**AGENDA
PLANNING COMMISSION MEETING
CITY OF SHOREVIEW**

**DATE: SEPTEMBER 24, 2013
TIME: 7:00 PM
PLACE: SHOREVIEW CITY HALL
LOCATION: 4600 NORTH VICTORIA**

TO: Planning Commission
FROM: Niki Hill, Economic Development and Planning Technician
DATE: September 19, 2013
SUBJECT: File No. 2495-13-22; Kevin and Sara Ousdigian, Minor Subdivision and Variances, 5107 Alameda Street

Figure 6: Dramatic ($\approx 35'$) shift in OHW to the east just south of lot line.

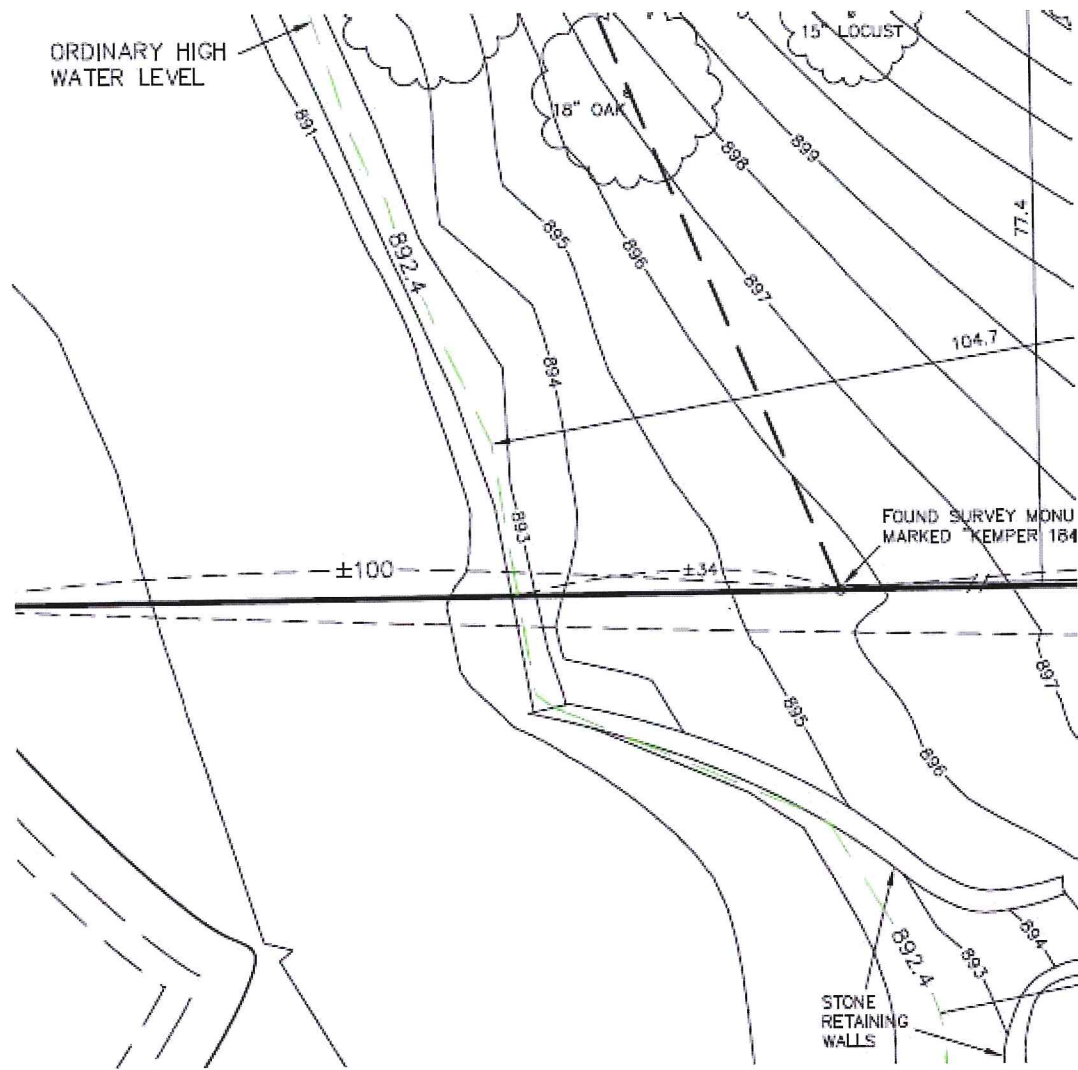
- 2) The OHW mark shifts dramatically eastward by about 35' within 25' of the south border of Parcel B (Figure 6 or survey). This causes the city computed setback to shift markedly to the east as seen in the survey with setbacks.
